STONE & WEBSTER ENGINEERING CORPORATION

Mr. Harold Denton
Director
Office of Nuclear Reactor Regulation
U. S. Nuclear Regulatory Commission
Washington, D. C. 20555

SEISMIC REEVALUATION OF PIPING ASSOCIATED WITH THE NRC SHOW CAUSE ORDER OF
MARCH 13, 1979, BEAVER VALLEY POWER PLANT (A6156) - JAD-146-79

BEAVER VALLEY POWER STATION UNIT 1
PIPING REEVALUATION

Figure 1. Problem No. 783A NUPIPE-II Model

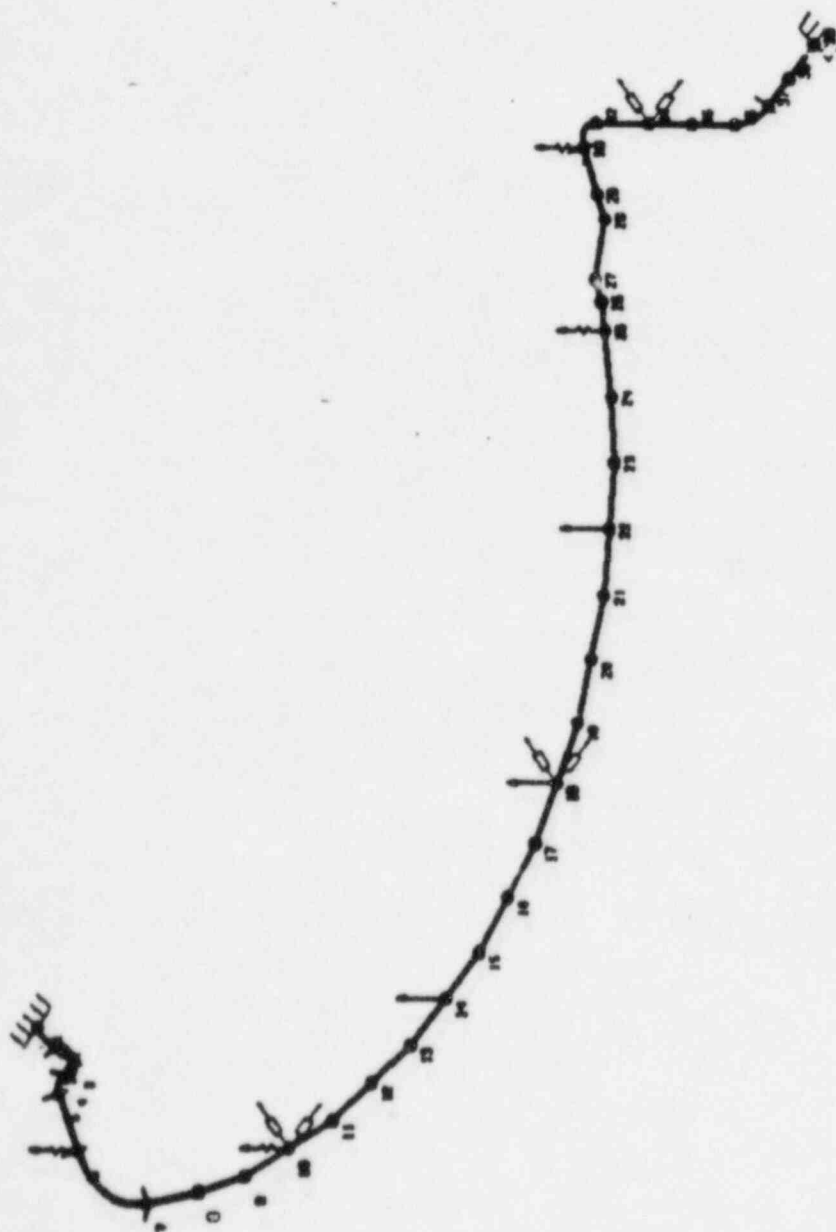
Load Case	Snubber & Hanger Support Stiffness		Snubber & Hanger Support Stiffness		S&W	Allowable	Ratio	
	Estimate		Rigid				①/②	③/④
	SRSS ①	Algb Sum ②	SRSS ③	Algb Sum ④				
Dead Load + P	6022	X	X	6035	7299	15,000	X	X
Dead Load + P + OBE	12,172	X	X	3854	15,677	18,000	X	X
Dead Load + P + DBE	13,054	X	X	9824	22,313	27,000	X	X
OBE	7617	3265	4091	3399	X	X	2.33	1.20
DBE	8517	4267	3794	4369	X	X	2.00	.87

Anchor movement loads calculated consist of all constraint displacements supplied. It is believed that S&W included their anchor displacements in their primary stress calculations. Due to the fact that they used only the end anchor displacements, this contribution was small. If the intermediate constraint displacements are also included, the OBE combined stress for Case I would be about 25% over allowable while the DBE stress would be about 10% over. If the seismic anchor stresses are included in the secondary stress calculations instead of the primary, as permitted in current code criteria, all stresses would be under allowable.

Hanger H-6 which was not shown on the work sketch was modeled at the location shown on the hanger drawings.

Modes 1 and 2 were the primary contributors to the seismic stress.

The effect of changing dynamic support stiffnesses from magnitudes in the 10^{16} range to 10^6 range shifted the first two modal frequencies as from 3.836 hz and 6.594 hz for 10^{16} to 3.807 hz and 5.463 hz for 10^6 . This shifts the second mode into a part of the spectrum.

Figure 2. Problem No. 12008 NUPIPE-II Model

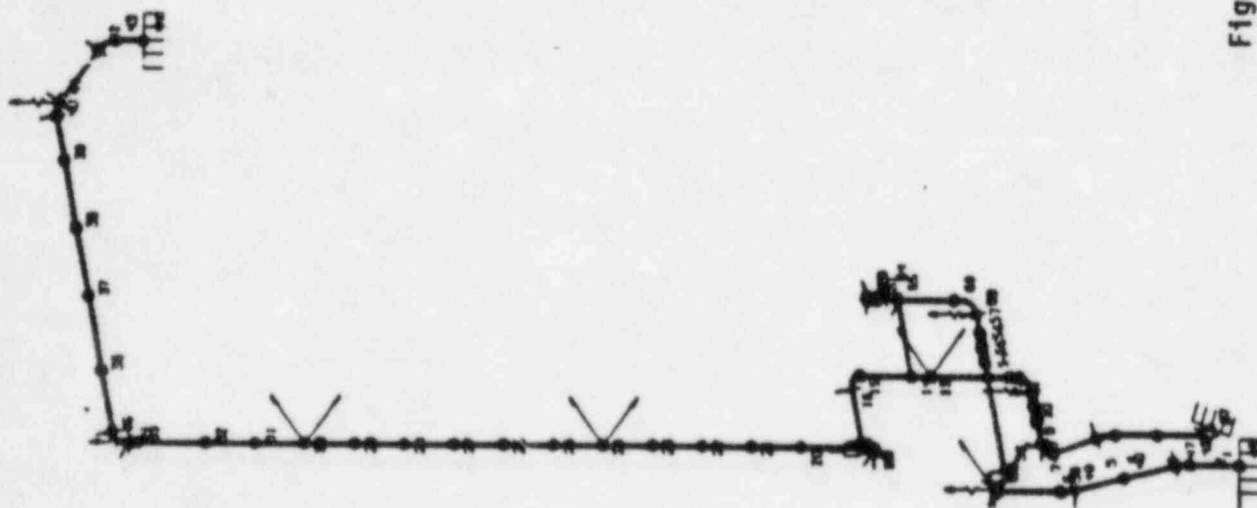
Load Case	Snubber & Hanger Support Stiffness		Snubber & Hanger Support Stiffness		S&W	Allowable	Ratio	
	Estimate		Rigid				①/②	③/④
	SRSS ①	Algb Sum ②	SRSS ③	Algb Sum ④				
Dead Load + P	5846 psi	X	X	5346 psi	7976	16000 psi	X	X
Dead Load + P + OBE	13 084 psi	X	X	7422 psi	16873	19200 psi	X	X
Dead Load + P + DBE	13728 psi	X	X	7584 psi	15930	29800 psi	X	X
OBE	8051 psi	2349 psi	8050 psi	2347 psi	X	X	3.43	3.43
DBE	8695 psi	2509 psi	8695 psi	2507 psi	X	X	3.47	3.47

Anchor movement loads calculated consist of all constraint displacements supplied using only the direction indicated by S&W. No OBE anchor movements were supplied. No intermediate earthquake constraint movements were supplied. It appears that S&W included earthquake anchor movements in their primary stress calculation. Our results indicate as S&W's do that the primary stresses with anchor movements included are within allowable for the DBE.

Modes 1 and 2 are the primary contributors to the seismic stress.

The effect of changing constraint and dynamic support stiffnesses from 10^5 to 10^{16} on the first two modal frequencies are small for this problem.

No valve eccentricities were given, therefore, our model does not reflect this effect.

Figure 3. Problem No. 255A NUPIPE-II Model (Part i,

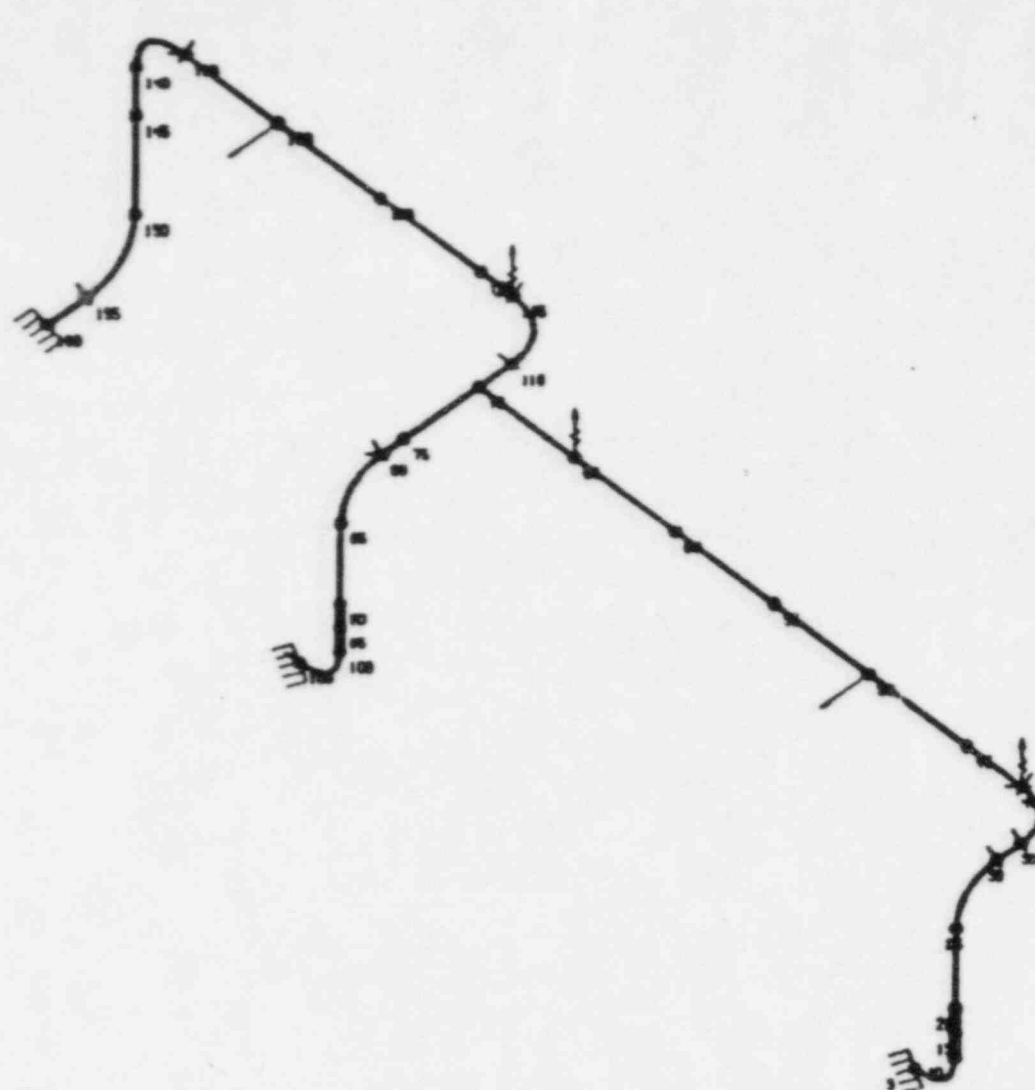
Load Case	Snubber & Hanger Support Stiffness		Snubber & Hanger Support Stiffness		S&W	Allowable	Ratio	
	Estimate		Rigid				①/②	③/④
	SRSS ①	Algb Sum ②	SRSS ③	Algb Sum ④				
Dead Load + P	5885 psi	X	X	5885 psi	6111	16300 psi	X	X
Dead Load + P + OBE	6444 psi	X	X	6378 psi	7719	19560 psi	X	X
Dead Load + P + DBE	6791 psi	X	X	6663 psi	8898	29340 psi	X	X
OBE	959 psi	1241 psi	956 psi	1241 psi	X	X	.77	.77
DBE	1382 psi	1793 psi	1377 psi	1792 psi	X	X	.77	.77

Anchor movement calculated loads consist of all constraint displacements supplied. OBE & DBE anchor movements and intermediate constraint movements were given.

All modes were at the zero period acceleration level. Three to four modes provided the primary contribution to the response.

The effect of changing constraint stiffnesses on system frequency was small.

S&W may have included earthquake anchor movements in their primary stress calculation. Since the earthquake anchor movement stresses are low (3000 psi) it doesn't make much difference where they are included.

Figure 5. Problem No. 203C NUPIPE-II Model

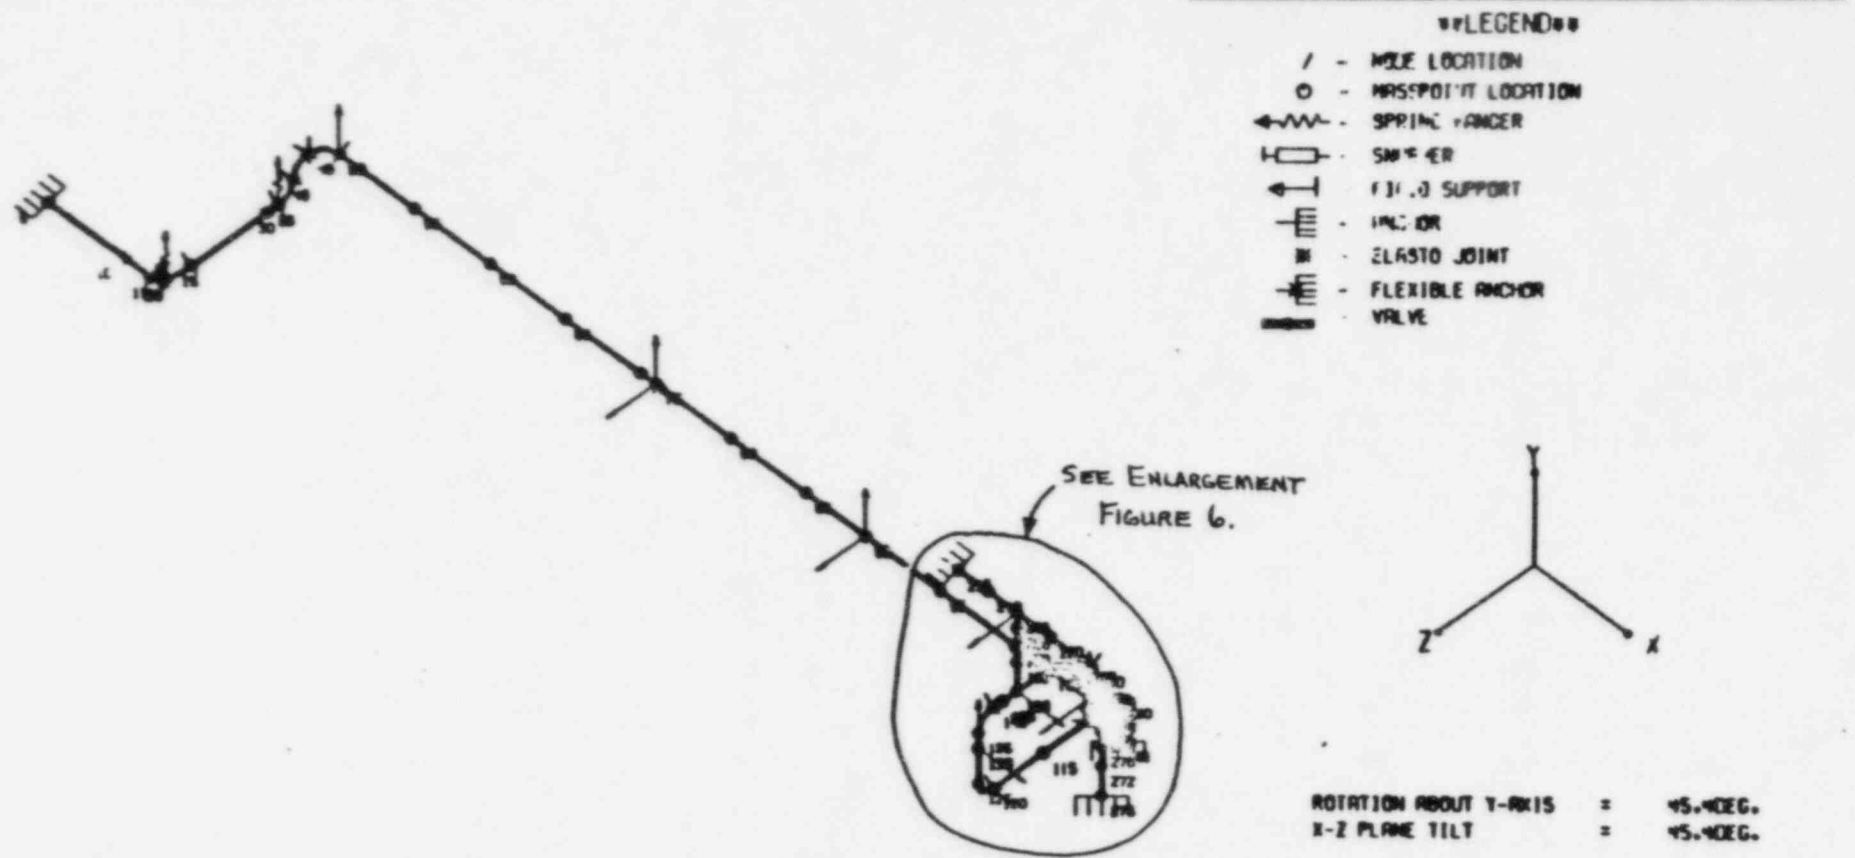
Load Case	Snubber & Hanger Support Stiffness		Snubber & Hanger Support Stiffness		S&W	Allowable	Ratio	
	Estimate		Rigid				①/②	③/④
	SRSS ①	Algb Sum ②	SRSS ③	Algb Sum ④				
Dead Load + P	3110	X	X	3106	3634	15000	X	X
Dead Load + P + OBE	4719	X	X	4202	5909	18000	X	X
Dead Load + P + DBE	5029	X	X	5170	6751	27000	X	X
OBE	3498	3550	3500	3536	X	X	1.00	.99
DBE	4360	4424	4459	4505	X	X	1.00	.99

The first three modes are:

Three modes, no other, primary contribution to the response.

Figure 7. Problem No. 204 NUPIPE-II Model

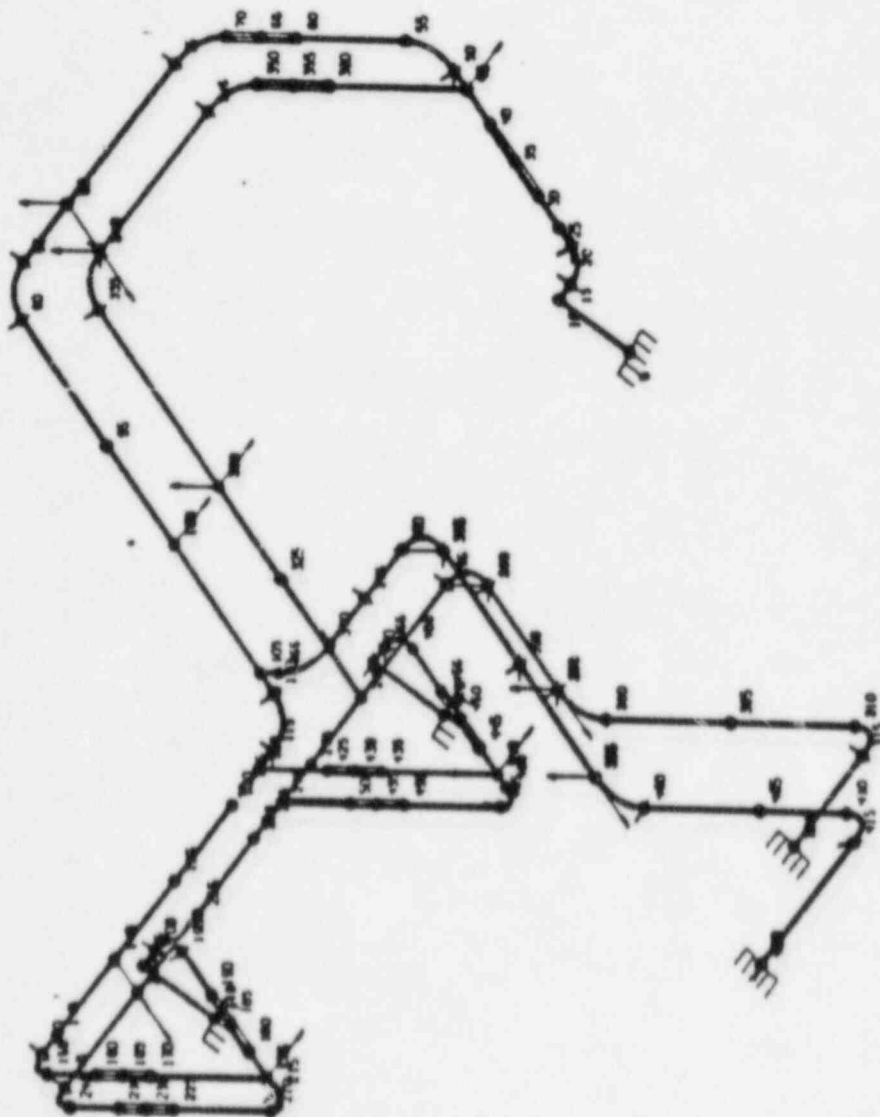
Load Case	Snubber & Hanger Support Stiffness		Snubber & Hanger Support Stiffness		S&W	Allowable	Ratio	
	Estimate		Rigid				①/②	③/④
	SRSS ①	Algb Sum ②	SRSS ③	Algb Sum ④				
Dead Load + P	5371	X	X	5440	5138	15000	X	X
Dead Load + P + OBE	8225	X	X	8380	7323	18000	λ	X
Dead Load + P + DBE	8860	X	X	8931	10842	27000	X	X
OBE	4098	4762	3697	4263	X	X	.36	.87
DBE	4734	5347	4318	4814	X	X	.89	.90

No seismic anchor movements specified.

For the EG&G Idaho analysis, rod hangers were input in dynamic support configuration. S&W apparently did not include them in their seismic analysis.

The first two modes provided the primary contribution to the response.
